BELLEFONTE COMBINED LICENSE APPLICATION – RESPONSE TO REQUEST FOR
ADDITIONAL INFORMATION – ONSITE METEOROLOGICAL MEASUREMENTS PROGRAMS

Subject: Onsite Meteorological Measurements Programs in the Final Safety Analysis Report

NRC Letter Dated: August 4, 2008
NRC Review of Final Safety Analysis Report
NRC RAI NUMBER: 02.03.03-05

Figure 2DD-204
BLN Lower Level (10-m) Wind Direction

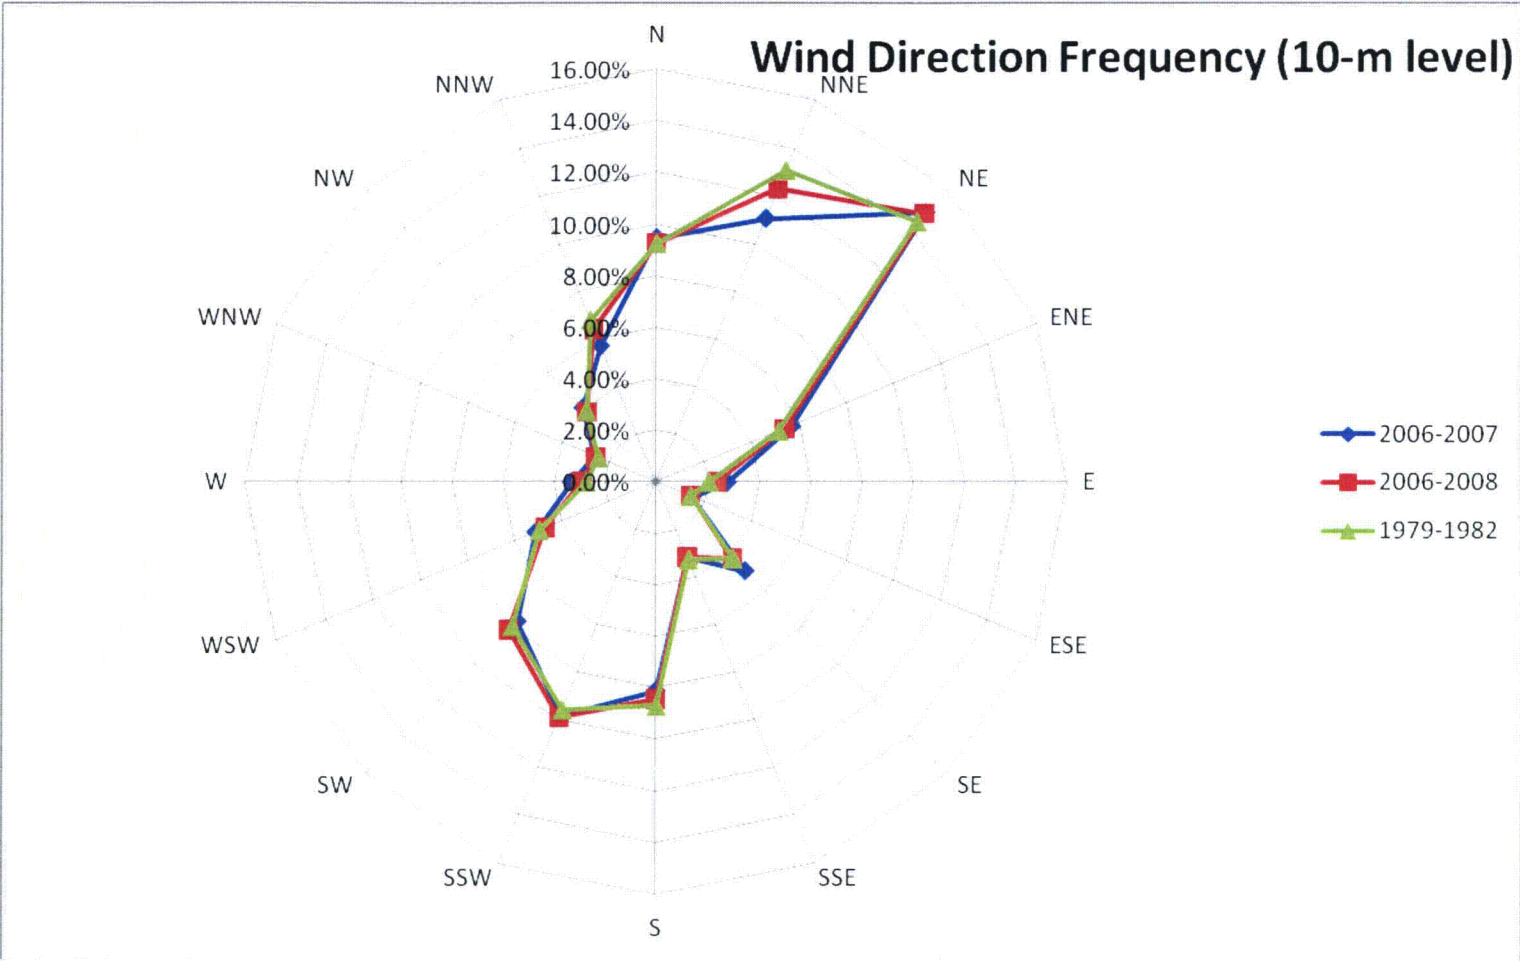
The NRC notified TVA that the wind rose figures (2DD-204 and -205), contained in the original response to this RAI, are not in accordance with typical direction oriented figures. They should be revised to match the compass headings, rather than alphabetically arranged.

TVA agrees with the NRC and is providing the attachment with the reoriented figures. No data has been changed.
